SAN ANTONIO WATER SYSTEM
Interdepartment Correspondence Sheet

Subject: Zoning Case Z2017260 (Laurel Ridge Treatment Center Hospital)

Date: September 27, 2017

ZONING FILE: LAUREL RIDGE TREATMENT CENTER (FIGURE 1)
ZONING CASE: Z2017260
MAP PAGE: 152, A5

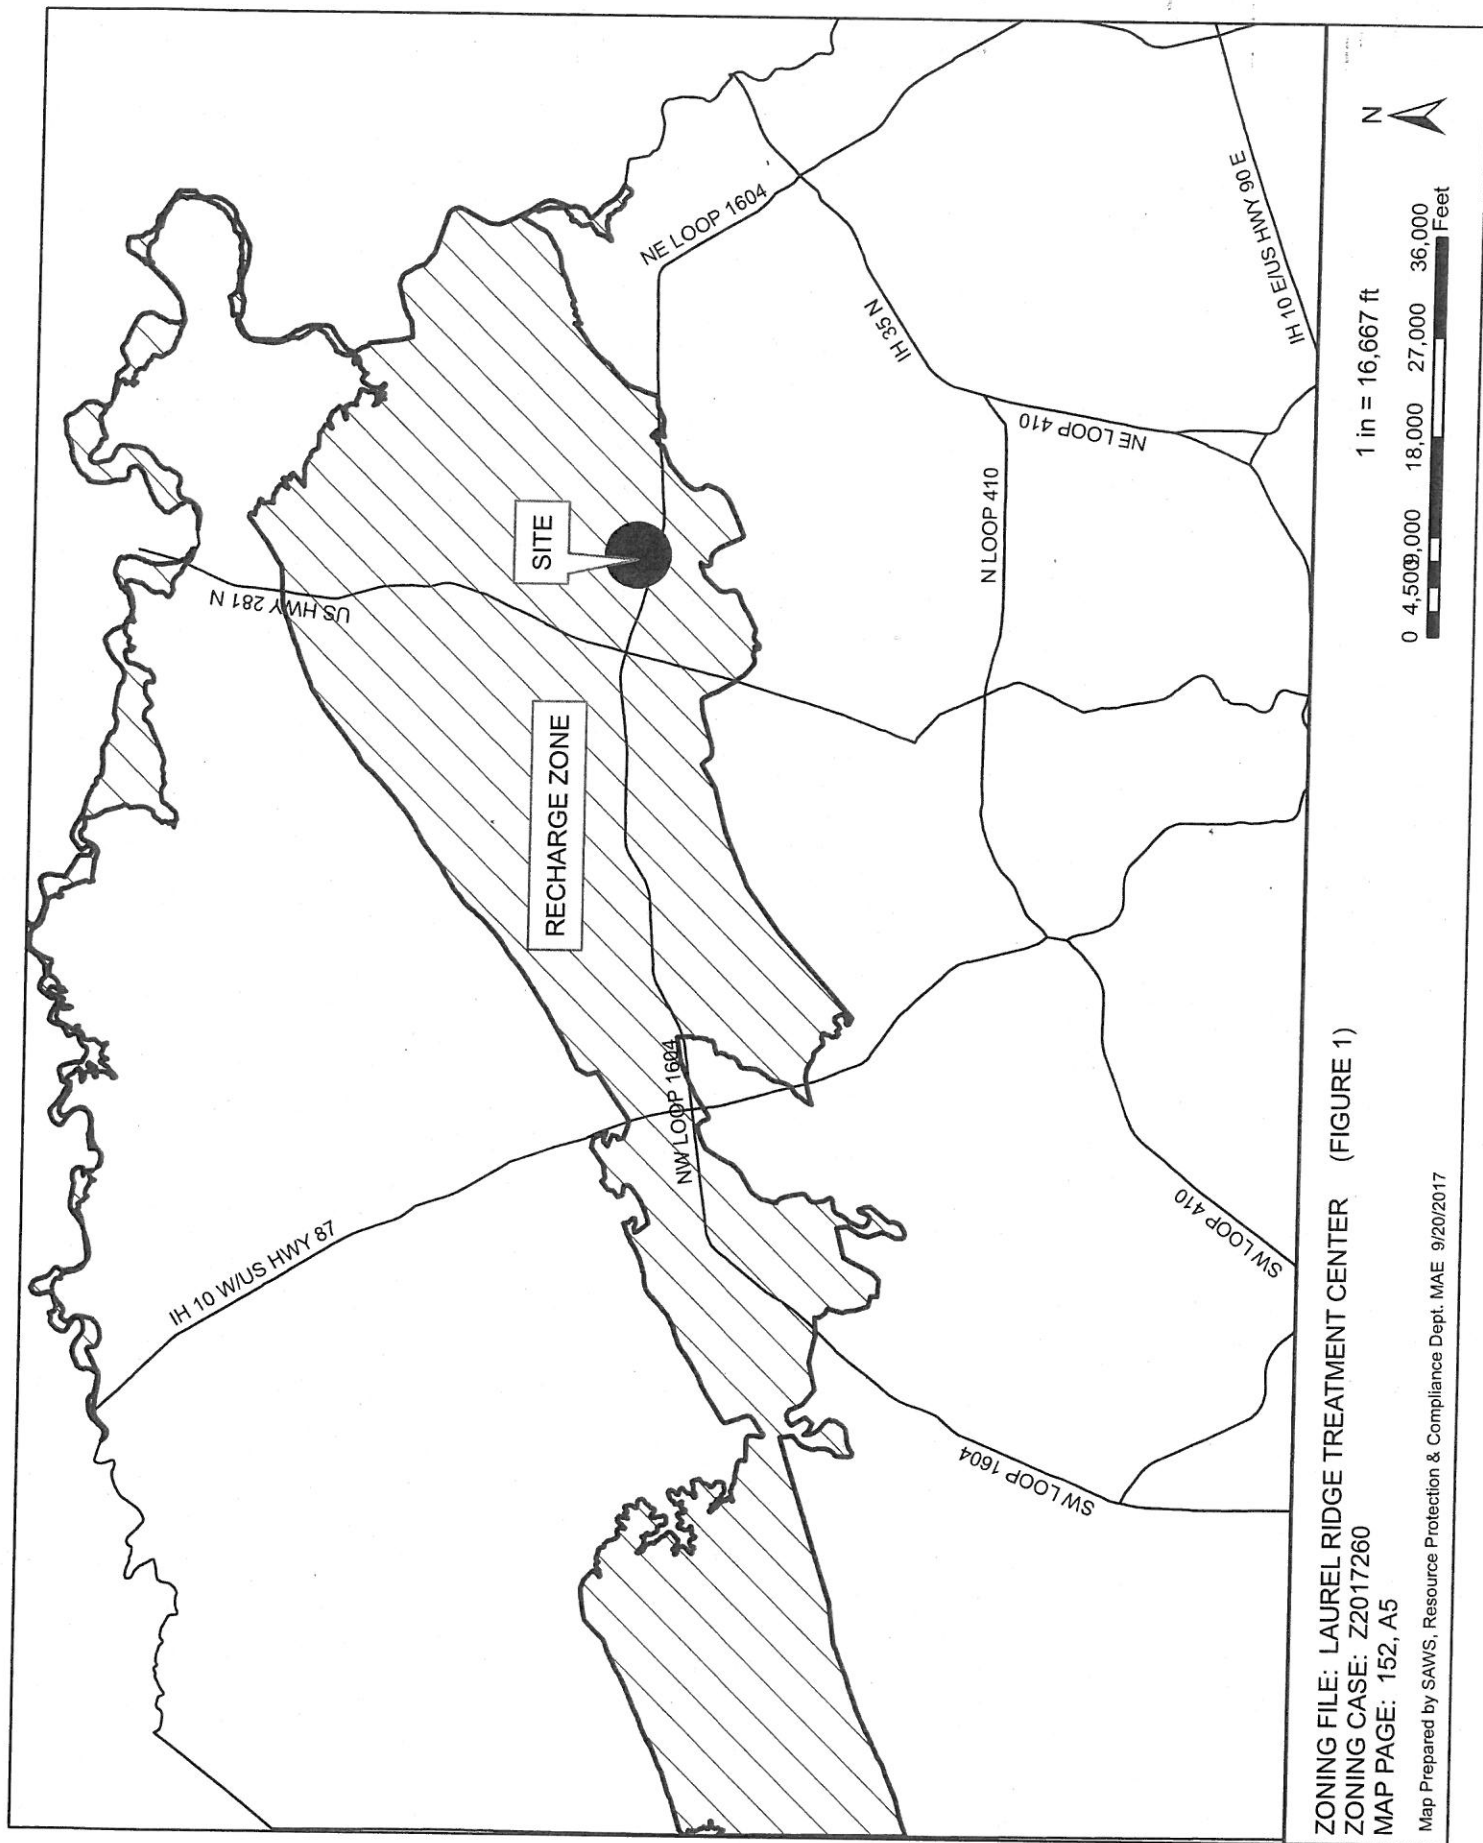
The subject property is located in City Council District 9, located 593 feet north of North Loop 1604 East on Redland Road. The property lies within the Edwards Aquifer Recharge Zone (Figures 1 and 2).
